**El Segundo Energy Center Project
(00-AFC-14C)
Steam Turbine Weatherization
Enclosures – Petition to Modify**

December 2015

***Submitted by: El Segundo Energy Center LLC
Date Submitted: 12-23-2015***

Sheet: **GENERAL ARRANGEMENT PLAN OVERALL SITE PLAN** **00U**

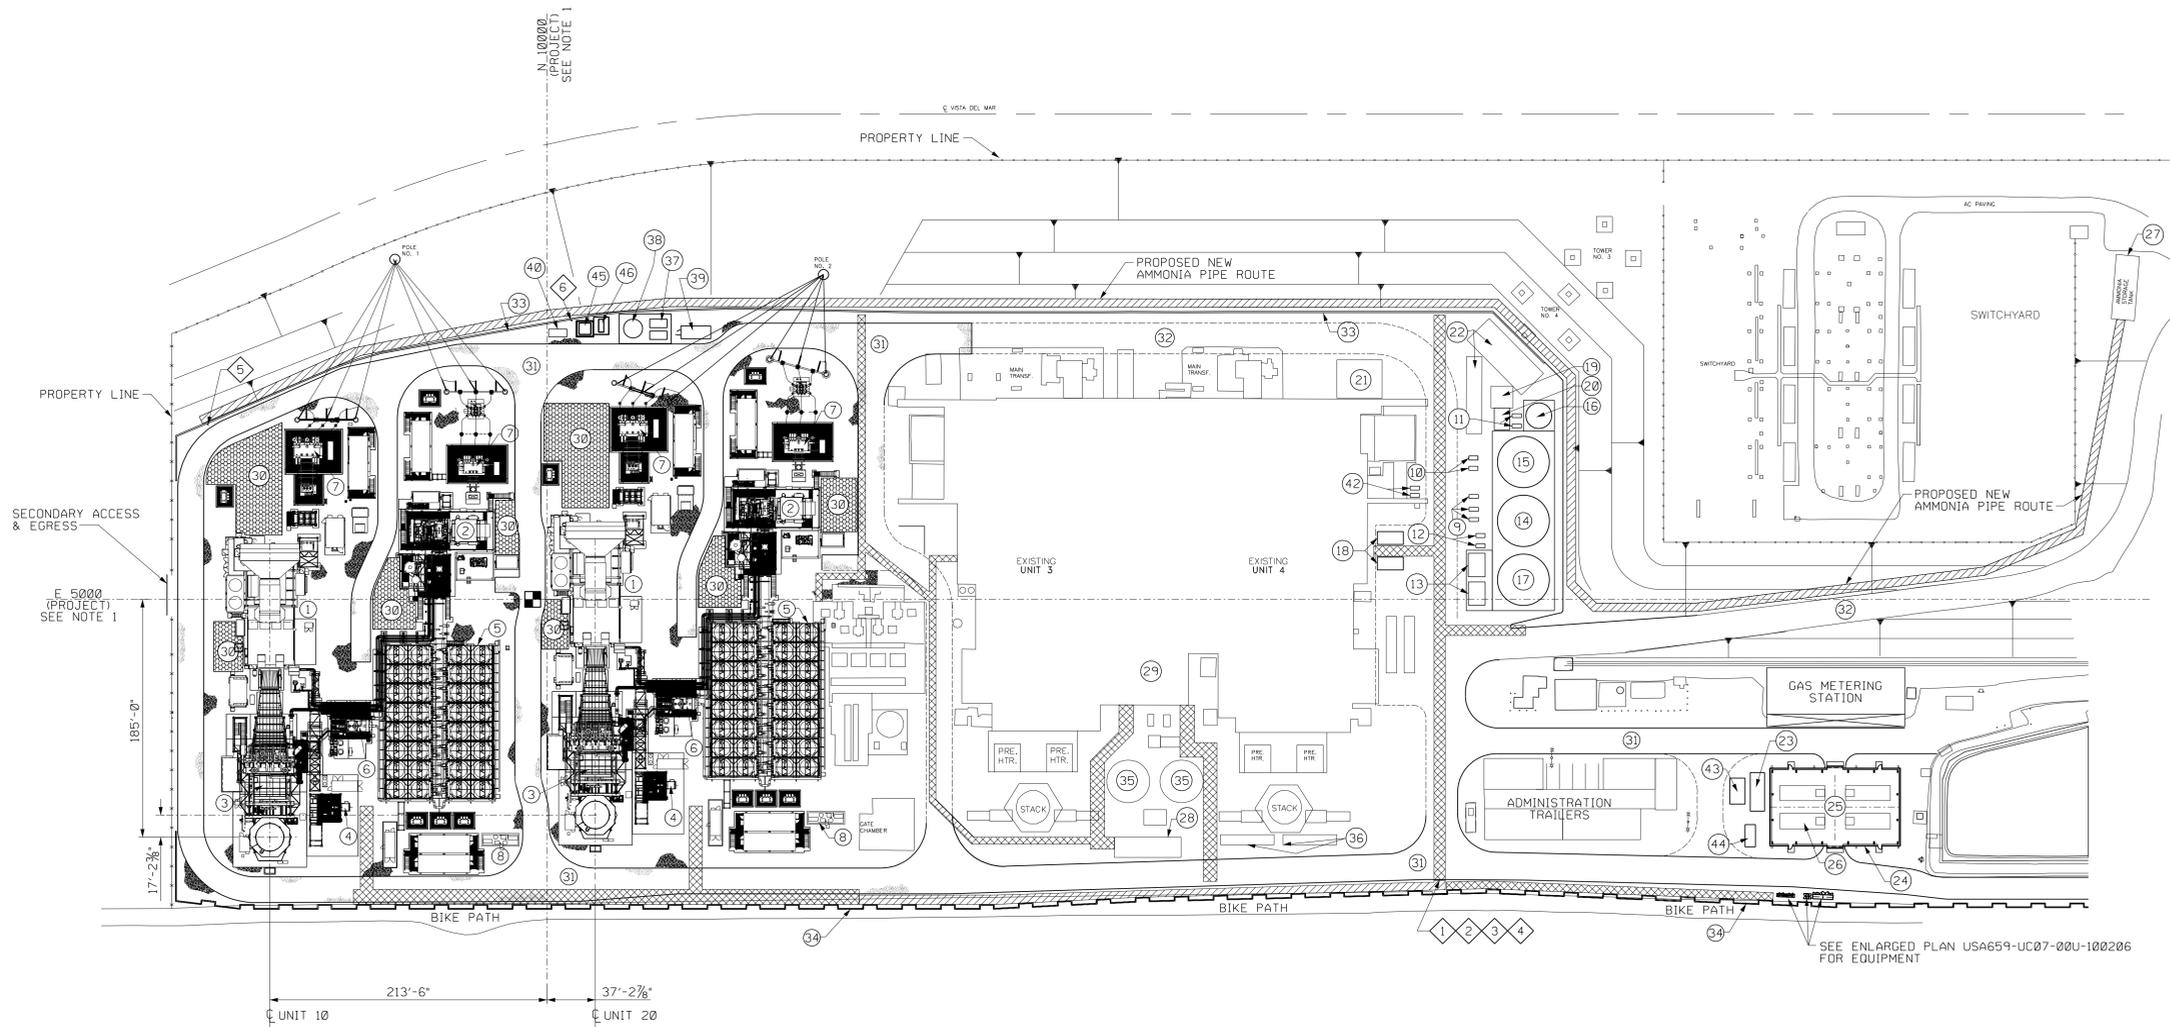
The ST units are located on the eastern half of the ESEC site (Attachment A, Item 2 on Site Arrangement Drawing), east of the air-cooled heat exchangers, and south of combustion turbine air inlets. The proposed enclosures are 21-feet in height, 20.67-feet wide, and 28.1-feet in length. They would be installed on the ST platform which is 14-feet in height. The total structure elevation height will be 35-feet above grade. For comparison, the ST generator is located immediately south of ST. The ST generator enclosure is 17-feet in height for total elevation of 31-feet above grade. Photos of the assembled enclosures, ST, and general installation locations are shown in Attachment F.

Steam Turbine Cover Design Drawings

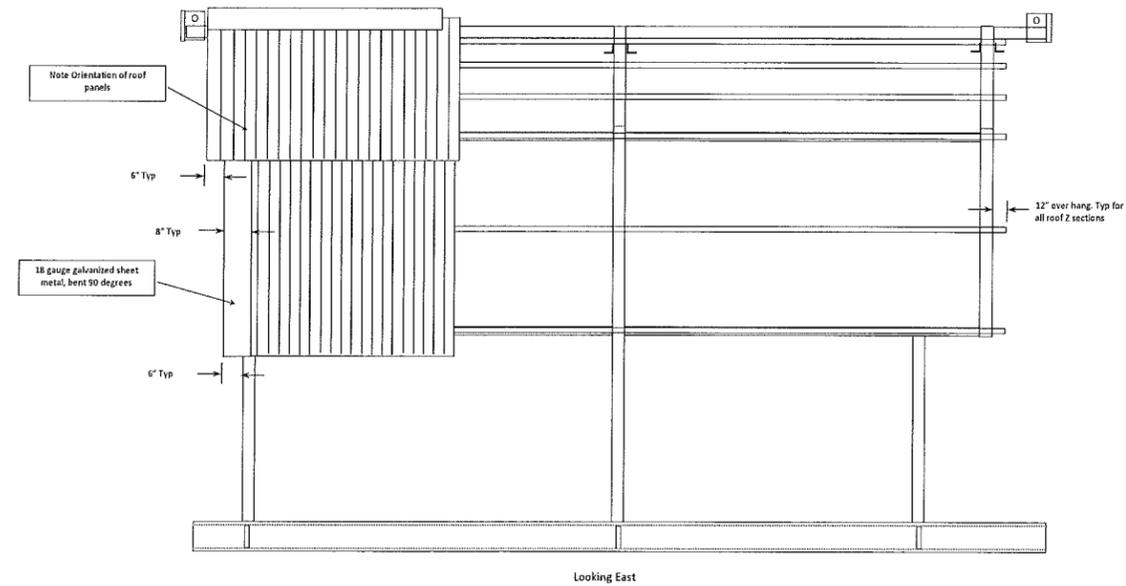
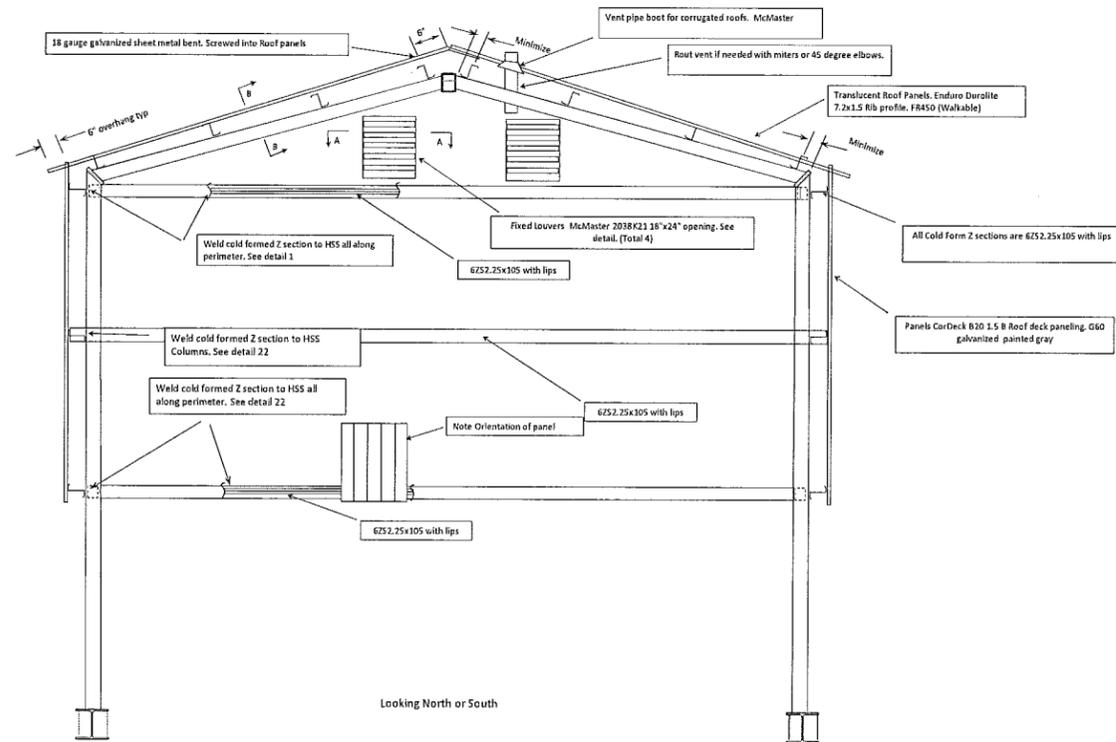
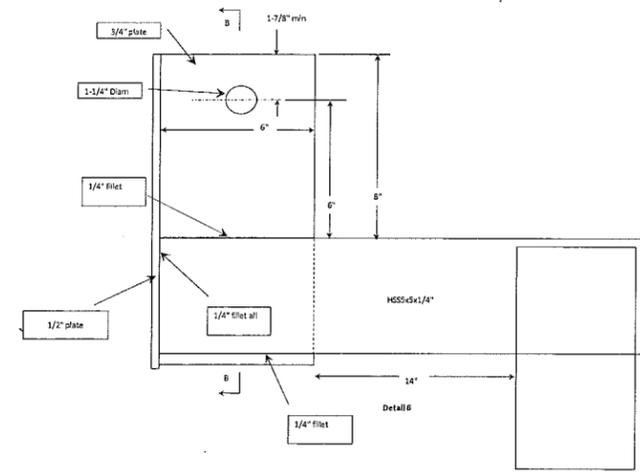
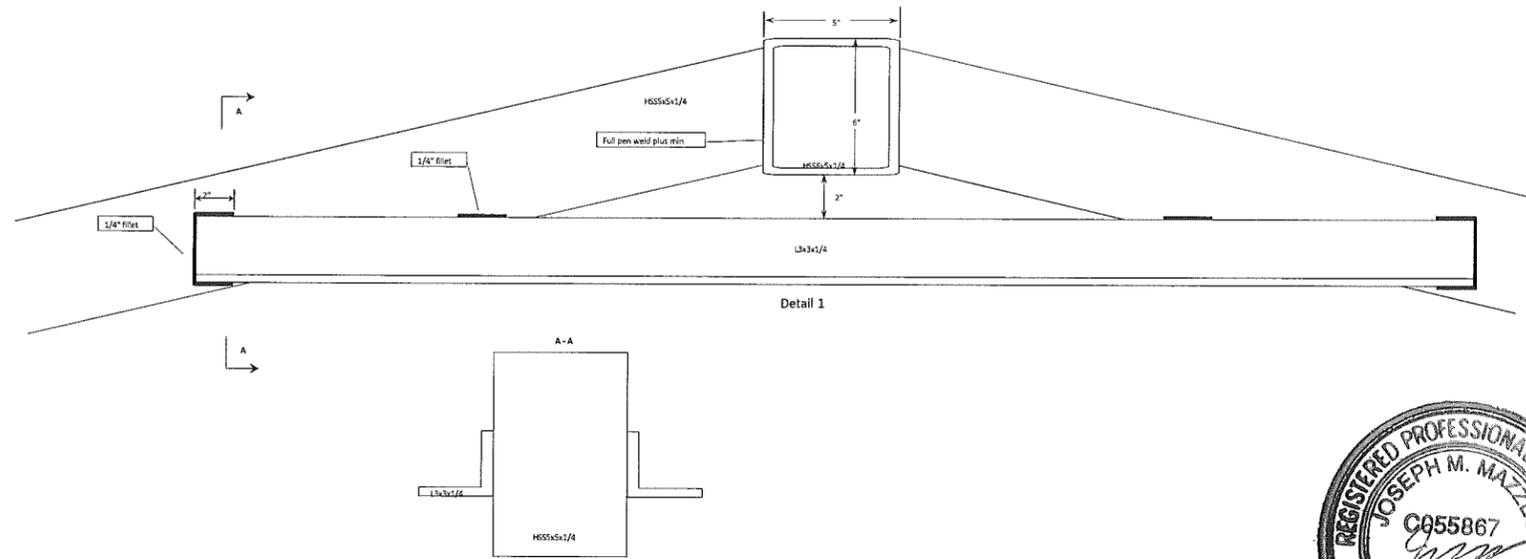
The proposed ST enclosures are steel framed, canopy type structures that will be bolt mounted to the turbine platform (Attachment C). The enclosures are designed to be bolted in place (not welded) to allow any future major maintenance activity possible by simply unbolting the structure and removing in a single lift in one piece. This greatly increases the efficiency of maintenance activities as compared the hard shell plaster coating as originally designed. The turbine platforms are constructed of steel I-beams and grated walkways. The enclosures were engineered and provided with PE Stamped design calculations and drawings (Attachment D). The enclosures are open on the bottom and will allow complete access around the ST for workers. There will be no enclosed work spaces created, and no electrical, plumbed, or mechanical systems installed on the enclosure. The enclosures were shipped to the site in parts and assembled on the ground in a staging area at the plant. The enclosures would be lifted into place with a crane in a single lift (Attachment E). Installation is estimated to require one day per enclosure.
